System Energy Resources, Inc.
1340 Echelon Parkway
Jackson, MS 39286-1995

CNRO-2006-00014

SUBJECT: Supplemental Information, Response to Request for Additional Information Regarding the Grand Gulf Early Site Permit Final Safety Evaluation Report (TAC MC 1378)

Responses to NRC Questions for Clarification Regarding the SERI February 22, 2006 Response to a Request for Additional Information on the Grand Gulf Early Site Permit Final Safety Evaluation Report.

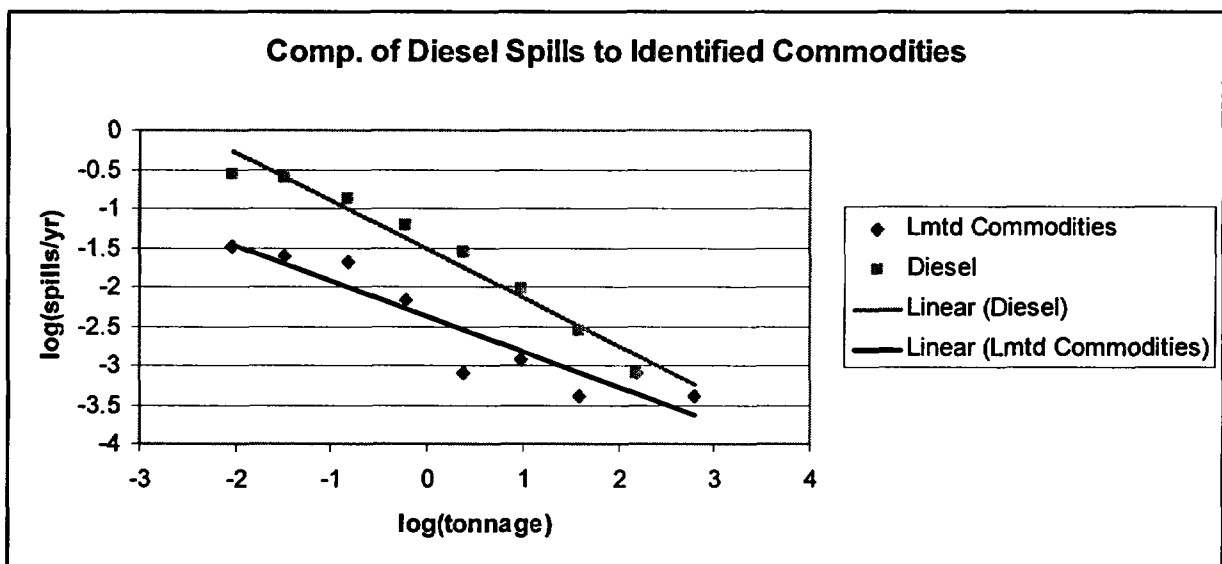
4. Page 22, 2.1 Spill Frequency Assessment: What is the basis for excluding spills involving commodities such as chlorine, coconut oil, diesel, lubricating oil, etc? It is reasonable to expect a spill being the result of some sort of loss of tankage integrity (e.g., puncture, rupture). Hence, there is no apparent functional relationship between the type of commodity and the initiation of a spill in the event of a barge mishap. Exclusion of spills on the basis of commodity type can lead to a significant underestimating of the spill frequency.

There are two ways to have approached the spill frequency. One is on a spill per vessel basis. Then it would make sense to include all spill types, generate a per vessel frequency, and then multiply by the number of vessels. This is not what was done in the analysis of Reference 1. Rather, a spill of combustible contents per river mile frequency was calculated. The advantage of this approach is that it is not necessary to know the number of vessels involved. If, in the approach of Reference 1, a total spill per river-mile frequency was calculated by including chlorine, coconut oil, diesel, lubricating oil, etc., the results would then have to be multiplied by the portion of spills that involved the commodities of interest (e.g., gasoline, benzene, etc.), and the exact same final result would have been obtained. That is, the spill frequency may go up by a factor of X, but the portion involving materials of concern with would be 1/X, and these numbers would be multiplied together.

The question might then be asked why incident data for distilled fuel oil (DFO) was included in the analysis of spill frequency. DFO was included initially because it considered to be a possible plume or detonation source. Once DFO was out of the plume and detonation calculations, consideration was given to removal of DFO spill incident data from the spill database. However, the additional DFO spills (128 out of 255) are effectively cancelled out when multiplied by the fraction of vessels containing gasoline, benzene, etc. Since the DFO spills amounted to 128/256 (0.50 of the total) and the percentage of DFO is 0.40 of the total quantities shipped, it is conservative to keep the DFO data.

As an example, consider the spill frequency versus tonnage relationship developed

in the RAI Response text (Section H). If the total number of spills in each bin is ten times greater, then the curve fit will be an order of magnitude greater ($f = 10 \cdot 10^{(-0.4871 \cdot \text{LOG}(\text{tonnage}) - 2.7457)}$). But then, when determining the fraction of spills that are one of the critical commodities, a multiplication factor of 1/10 would be applied, providing the same equation, $f = 10^{(-0.4871 \cdot \text{LOG}(\text{tonnage}) - 2.7457)}$ again.

Of course, the new spills may not increase each bin total by an identical ratio. If the new spills tended to be of a smaller size, they would tilt the curve fit such that it would have a more negative slope. Evaluation of diesel spills (all spills in the MislVslPoll database identified as diesel, some 2102 spills), show this is the case. A plot of curve fits to diesel spills and to the commodities previously identified is shown below. Since the diesel curve fit is steeper, it would be non-conservative to include diesel spills.
